L-2016-101
10 CFR 52.3
10 CFR 52 Appendix D

May 6, 2016

Re: Florida Power & Light Company
Proposed Turkey Point Units 6 and 7
Docket Nos. 52-040 and 52-041
Voluntary Submittal of Exemption Request and Design Change Description for
Departure from AP1000 DCD Revision 19 to Address Main Control Room
Habitability Analysis

PTN DEP
6.4-2

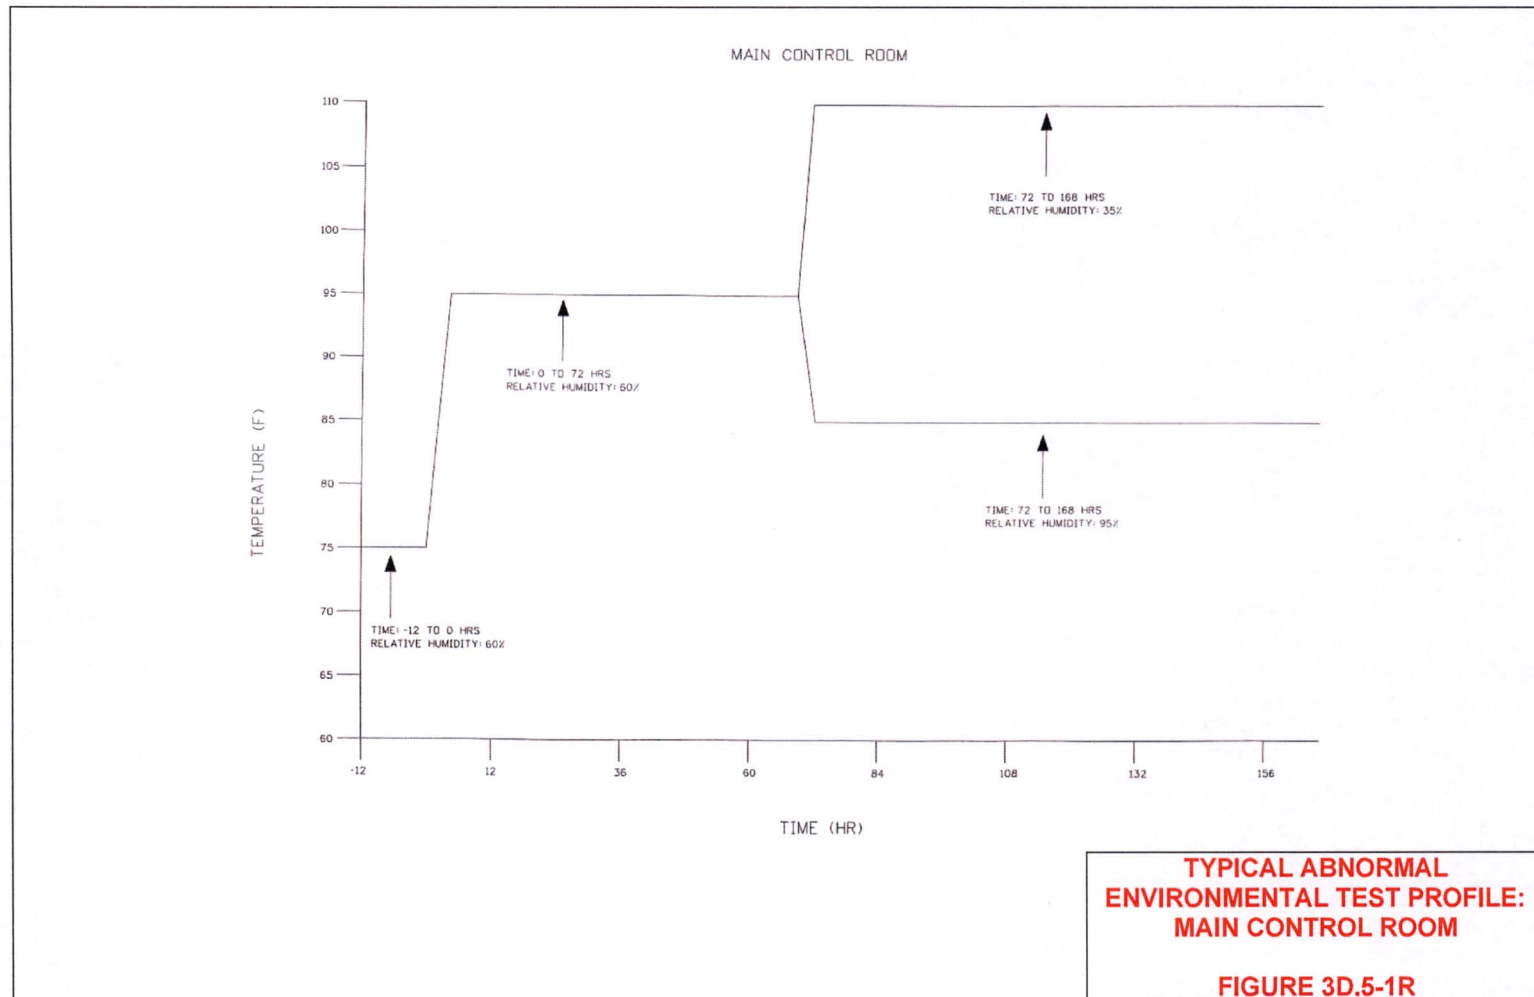
8. COLA Part 2, FSAR Chapter 3, Appendix 3D is revised to add FSAR Figure 3D.5-1R with left margin annotation PTN DEP 6.4-2 as follows (departure from DCD Figure 3D.5-1 (Sheet 1 of 3)):

20. COLA Part 2, FSAR Chapter 7, is revised to add new Figure 7.2-1R (Sheet 2 of 2) with left margin annotation PTN DEP 6.4-2 as follows (departure from DCD Figure 7.2-1 (Sheet 13 of 21))departure from DCD Figure 7.2-1 (Sheet 13 of 21)):

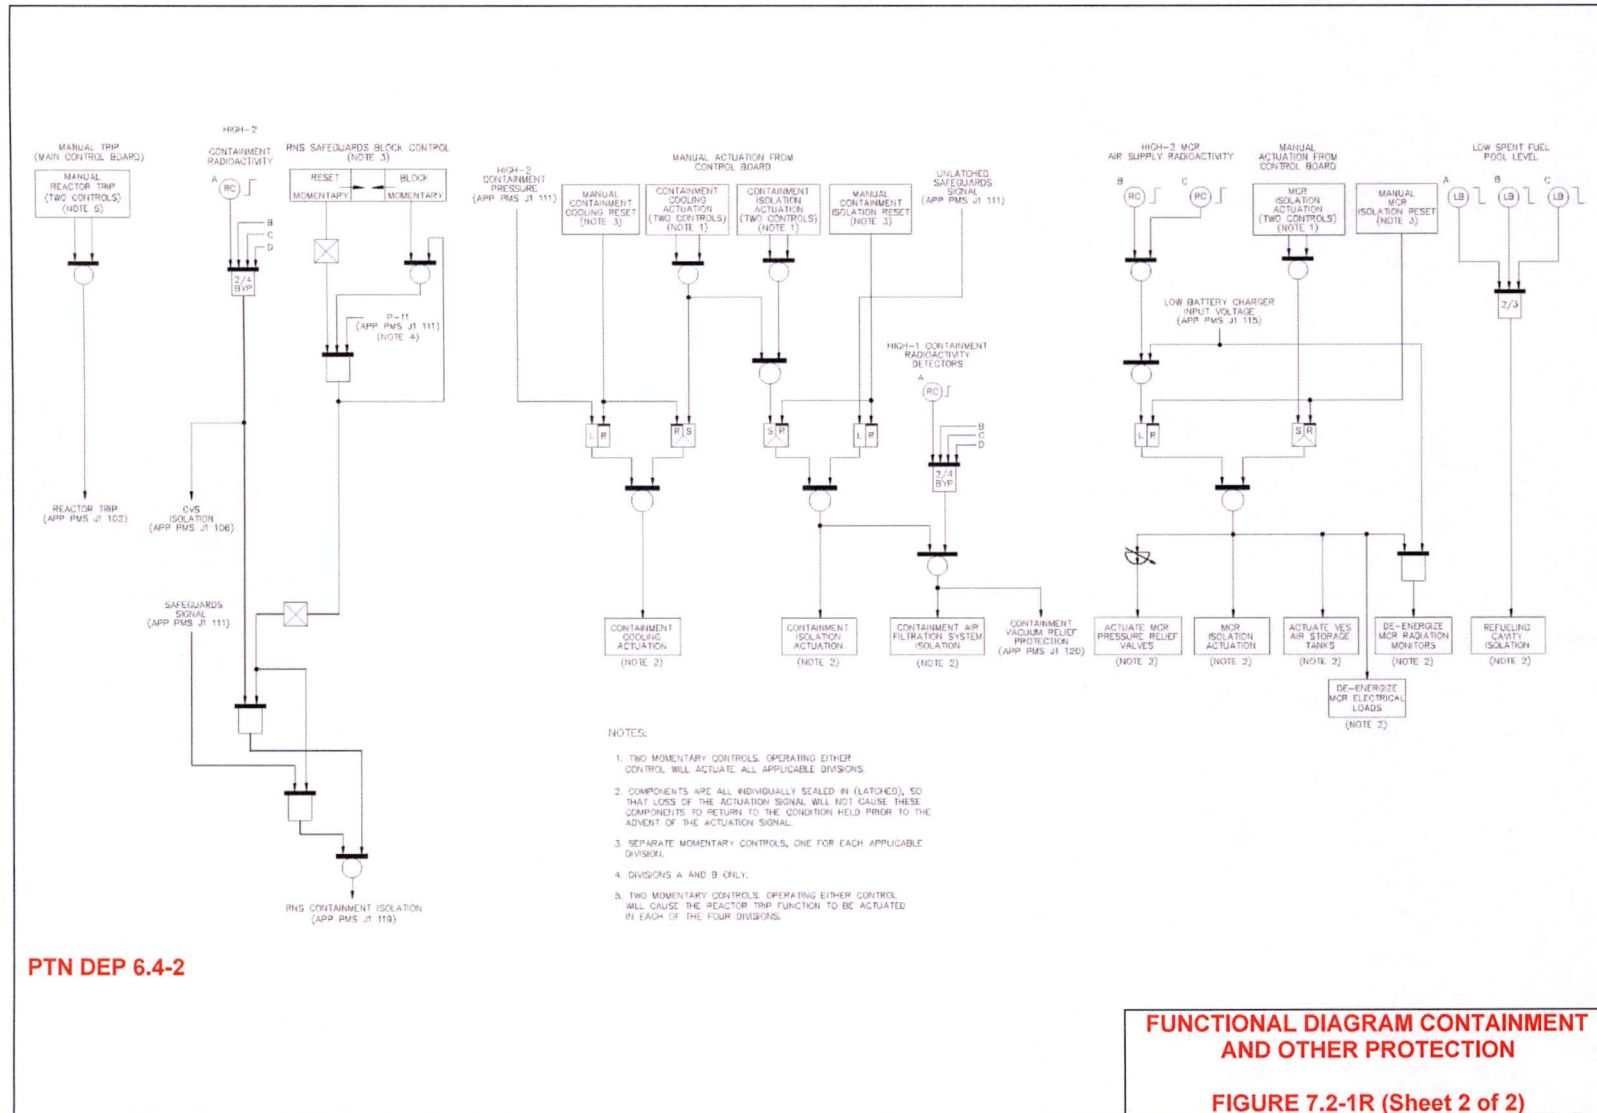
PTN DEP 6.4-2 **The functional logic relating to main control room isolation, air supply initiation, and electrical load de-energization is illustrated in Figure 7.2-1R (Sheet 2 of 2).**

Figure B 3.7.6-2
Compressed Air Storage Tanks Minimum Volume – One Bank of VES Air Tanks
(8 Tanks) Inoperable

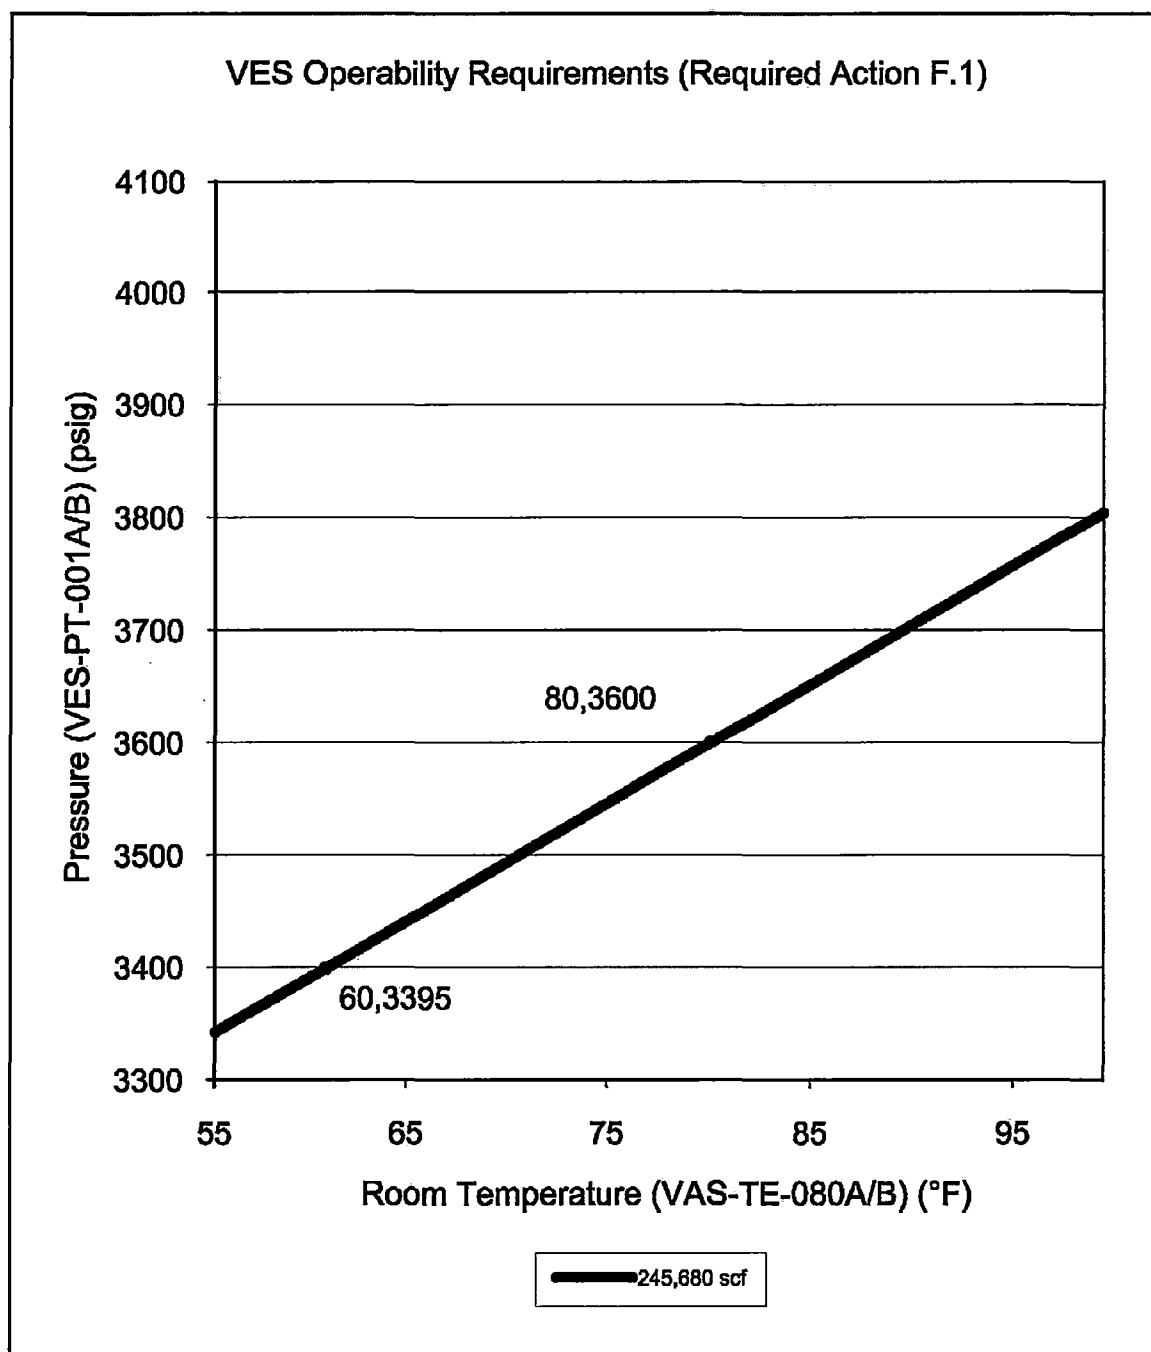
Tier 2 Table 3.7.3-1 (Sheets 1 and 2 of 3), Table 3.9-12 (Sheet 6 of 7), Table 3.9-16 (Sheet 23 of 26), Table 3.9-17, Table 3.11-1 (Sheets 17, 30 and 47 of 51), Figure 3D.5-1 (Sheet 1 of 3), Table 3I.6-2 (Sheet 11 of 28), Table 3I.6-3 (Sheets 10 and 28 of 32), Subsections 6.4.2.2, 6.4.2.3, 6.4.3.2, 6.4.4, 6.4.5.1, 6.4.5.3 and 6.4.8, Table 6.4-3, Figure 7.2-1 (Sheet 13 of 21), Subsection 7.3.1.2.17, Table 7.3-1 (Sheet 7 of 9), Table 7.3-3 (Sheet 2 of 2), Table 7.5-1 (Sheet 11 of 12), Table 7.5-7 (Sheet 4 of 4), Subsections 9.3.1.1.2, 9.4.1.1.2, 9.4.1.2.3.1 and 14.2.9.1.6, Table 14.3-7 (Sheet 1 of 3), TS 3.3.2, TS 3.7.6, TS B 3.3.2, TS B 3.7.6, TS Figure B 3.7.6-2.
